Request for Review of Comment Submitted but not addressed

RE: Black Diamond "The Villages" Preliminary Plat 2C

From: Kristen Bryant and William and Karen Bryant

A portion of the map showing the buffer in question. This was taken from plat drawing 06-PP1.pdf.

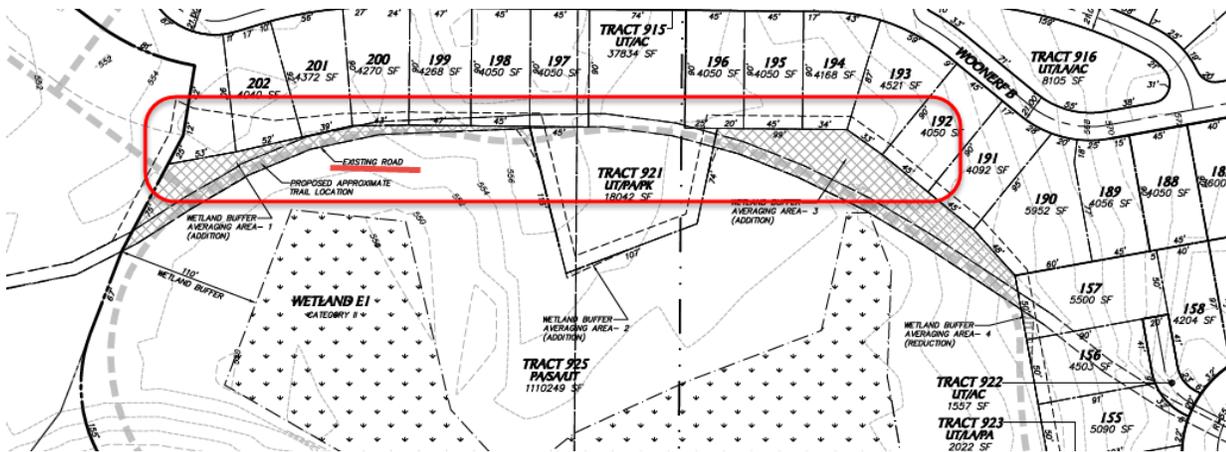
Buffer on the north portion of wetland E1 is incorrect.

This buffer does not follow Black Diamond Municipal Code or follow wetlands standards from the Department of Ecology.

The thick grey dashed line shows a trail and buffer edge. The averaging plan shows buffer the applicant marks as "added" to the north of this trail. In fact, this is much smaller than the required buffer.

Comment: The underlined portions above demonstrate that the wetlands reviewer did not visit the logging road in question. They relied on city staff who are not wetlands experts. Had the visit been done, it would be shown that the road is not solid-surface, and relatively little work would be needed to restore the vegetation to make this a functioning buffer.

Comment [K1]: The underlined portions note that you cannot apply this condition to a surface that is not a hardened surface or improved road. These old trails are neither.

Comment [K2]: There is every reasonable expectation that this old road on this property would be restored. The preliminary plat should not be approved unless this portion of BDMC is adhered to by requiring a condition for restoration of the buffer over the logging road on E1, and full buffer width for E1 is put in place.

If the road really were a solid surface separating the road from ecological functions of the buffer, then the applicant would not add buffer averaging north of it (see map). In truth, there is no separation and the ecological function needed is the much wider 110' buffer.

Action Requested: Require the full buffer width on the north portion of wetland E1, and restoration of the vegetation.
